Development Permit Panel

Wednesday, March 11, 2020
3:30 p.m.

1. **DEVELOPMENT PERMIT 17-766824**
(REDMS No. 6393525)

2. **DEVELOPMENT PERMIT 18-835723**
(REDMS No. 6398694 v. 4)

Drawn:	RS
Checked:	MC
Scale:	1/16" = 1'-0"
Project Number:	
Revision Date:	
Dwg. No.:	D02

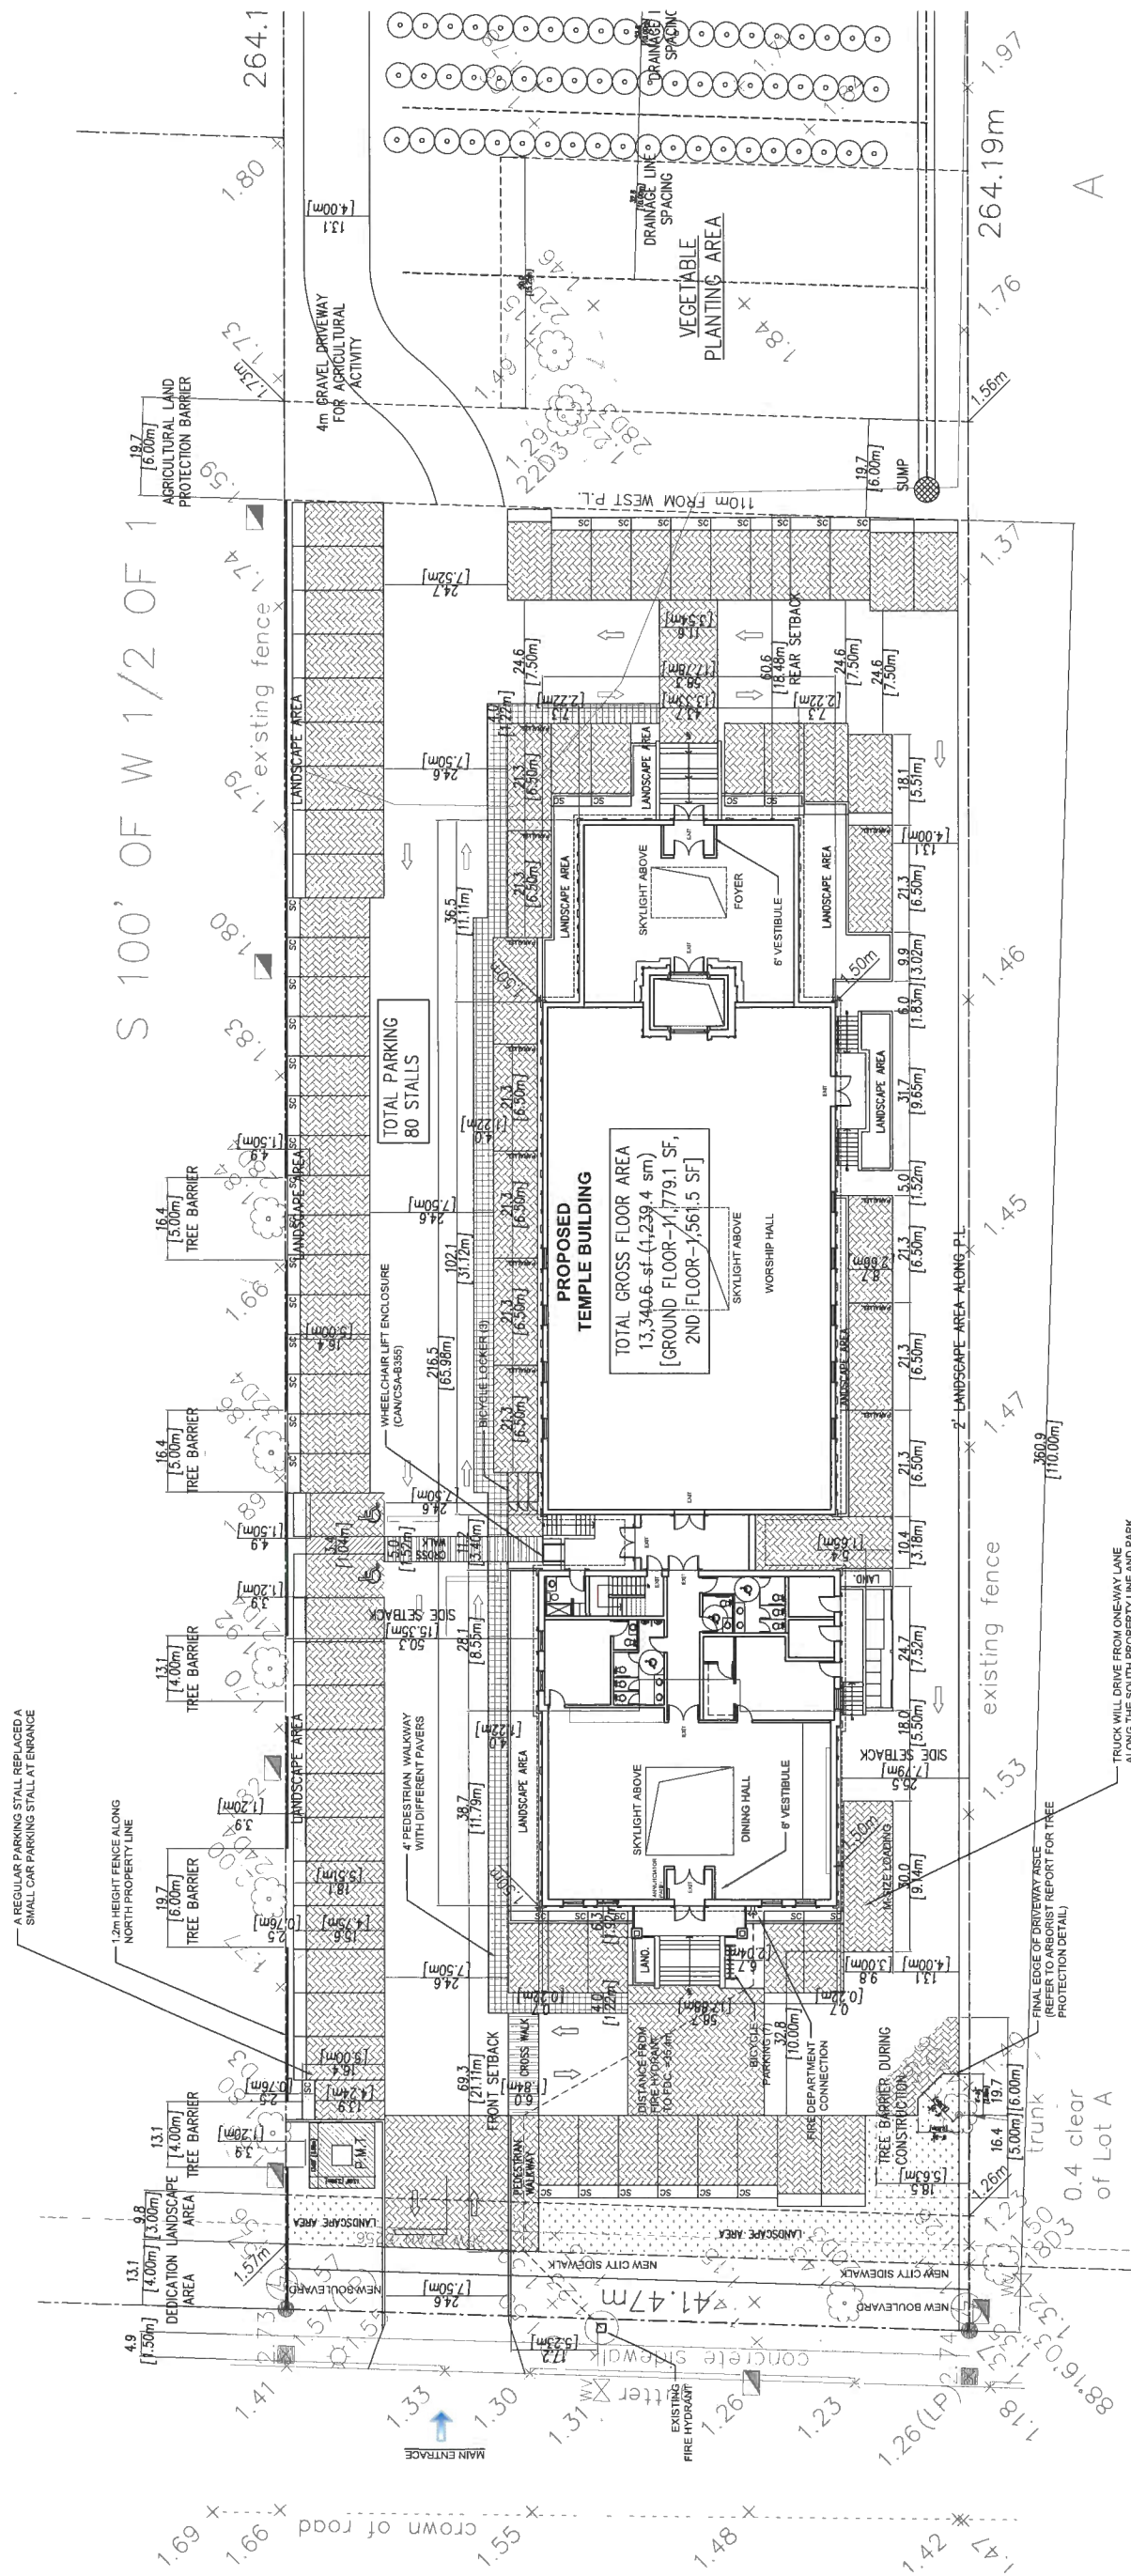
- support the comment to delineate on-site pedestrian circulation areas to avoid pedestrian conflict with vehicular circulation on the site;
4' walkway around the building with different pavers provided to define pedestrian and vehicle traffic, refer to D01, 02.

The main entrance to the temple has been relocated to the north side of the property in order to provide a gathering area in front of the temple, refer to D01, 02.

Revision No.
D05

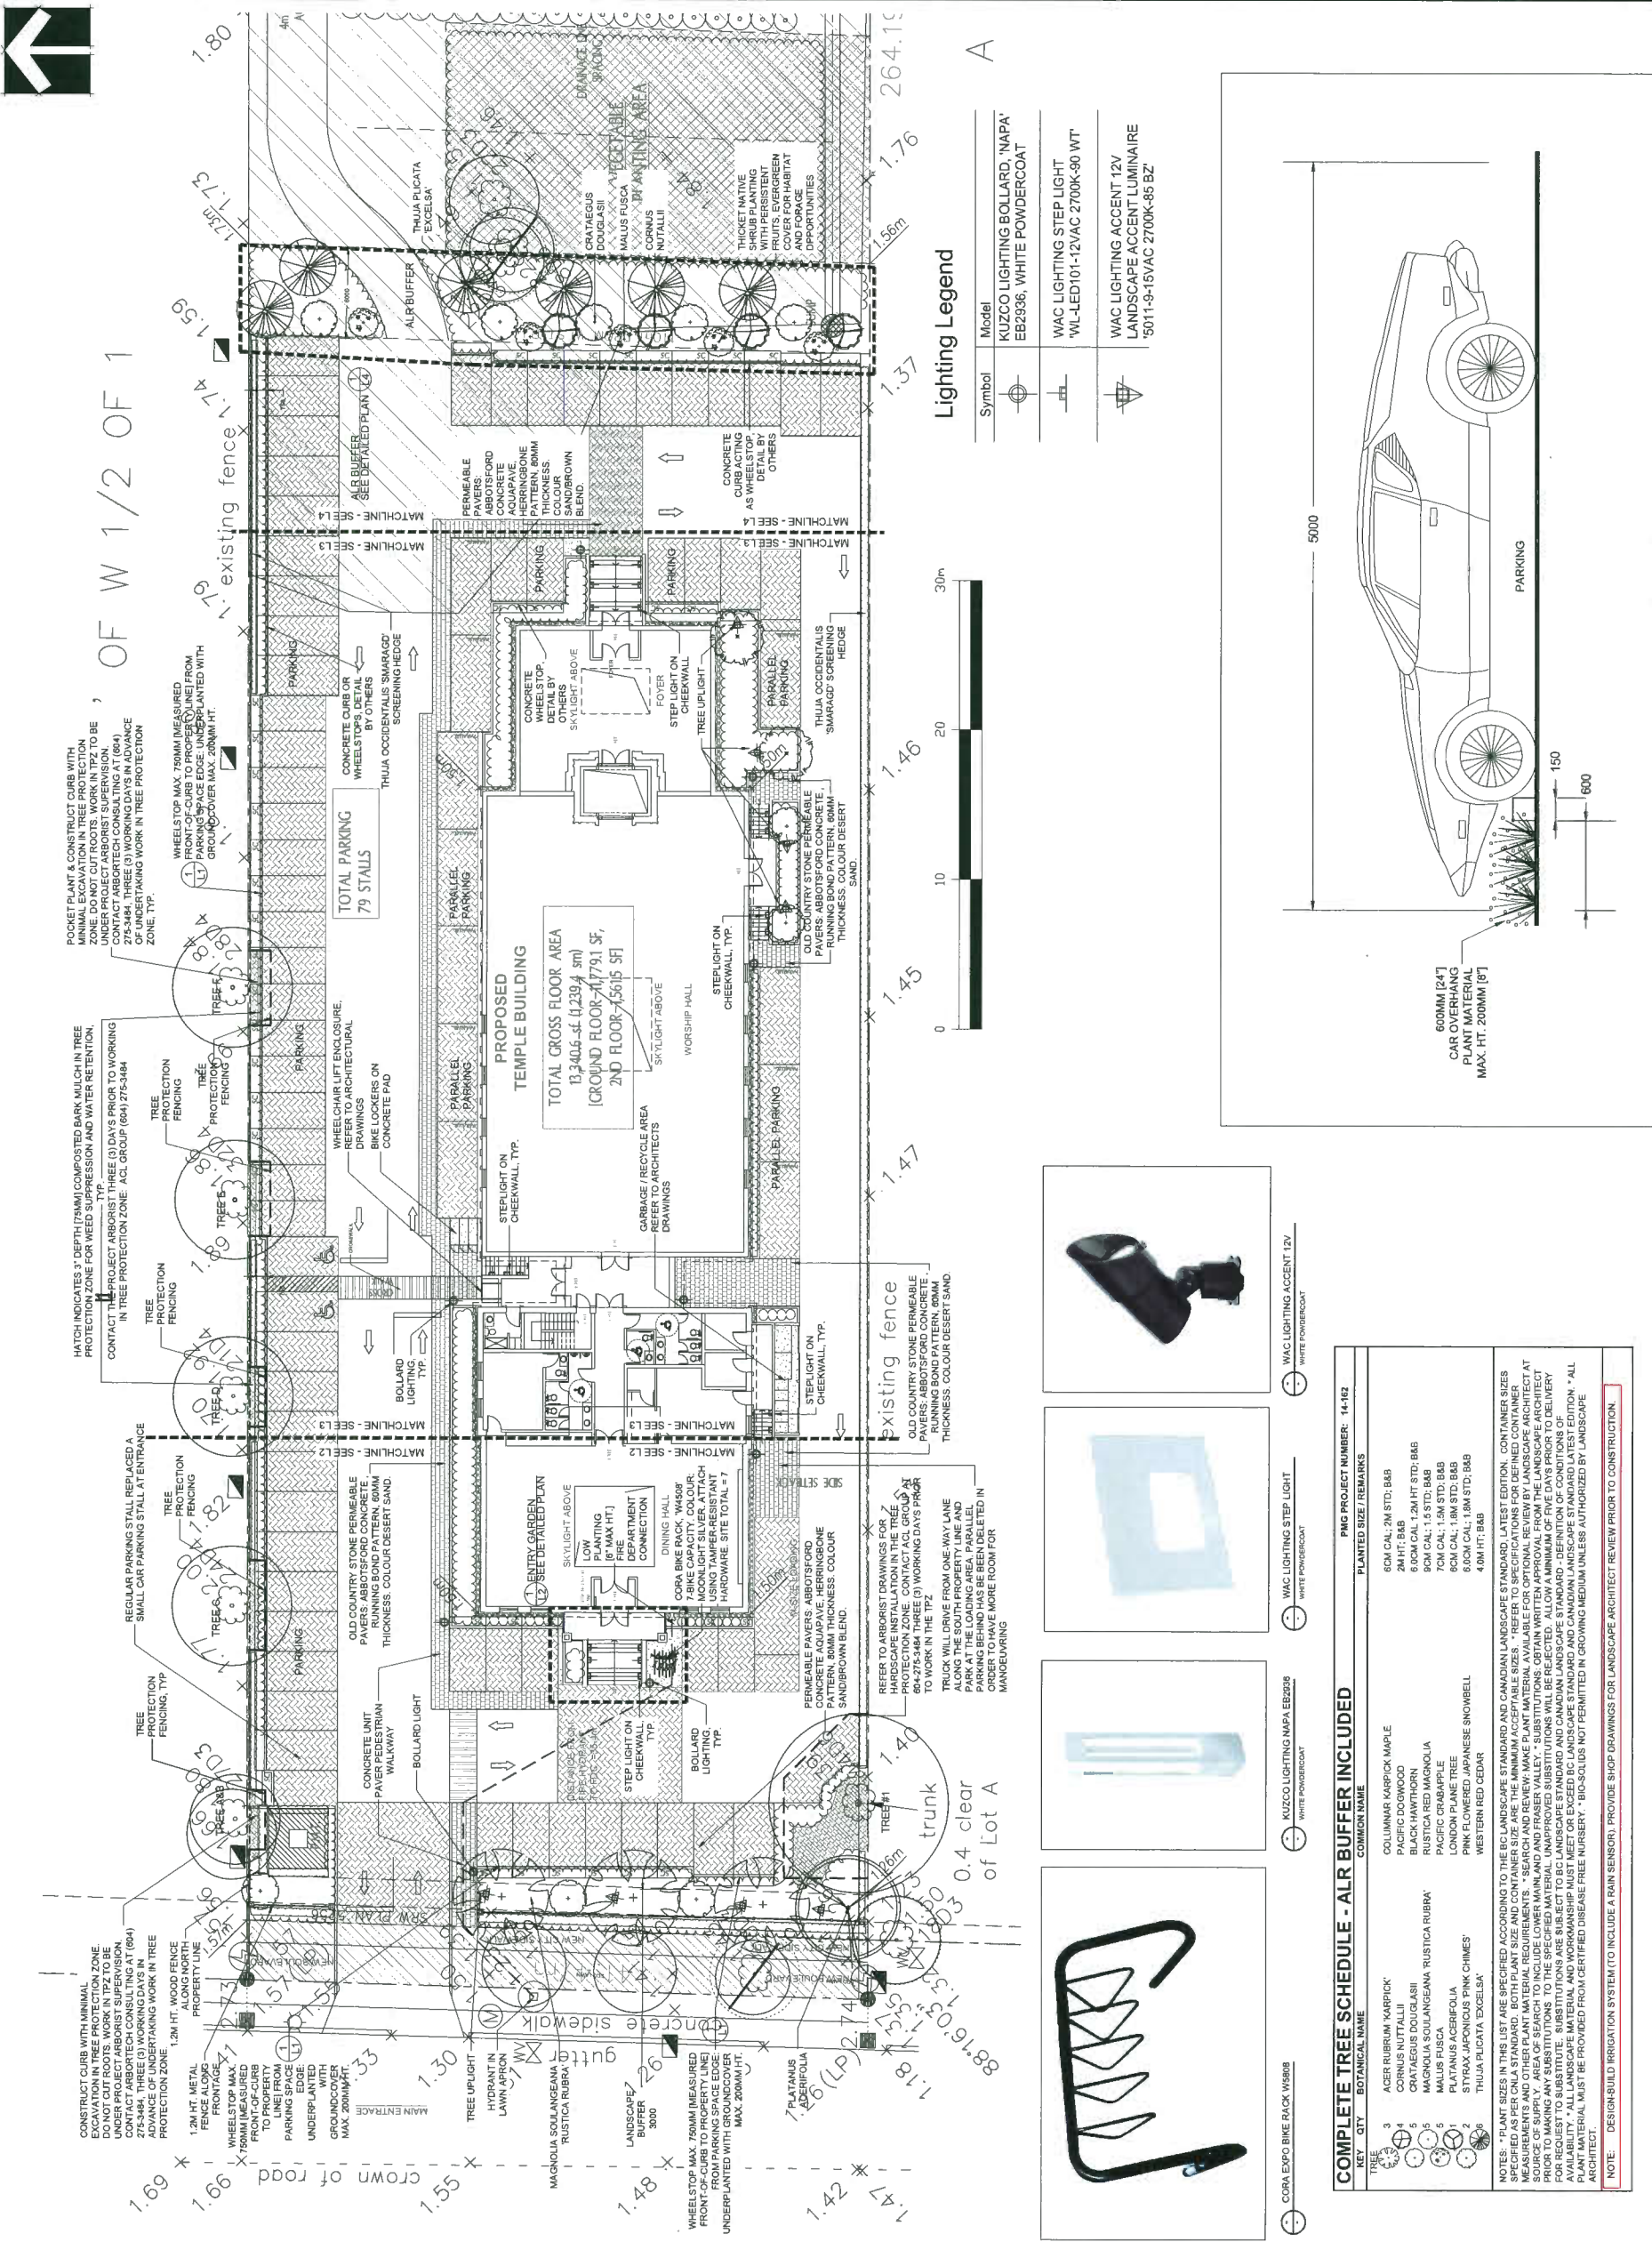
- appreciate the applicant for showing mechanical units and the parapet wall screening on the rooftop in the roof plan to hide the mechanical units; however, consider installing fencing around these units consistent with the building's architectural features to provide additional screening;

All of the mechanical unit will be screened by the 4' parapet at roof. Parapet will have the same architectural style as the temple façade, so that the building elevation will be consistent, refer to D05 for parapet detail to screen mechanical unit.
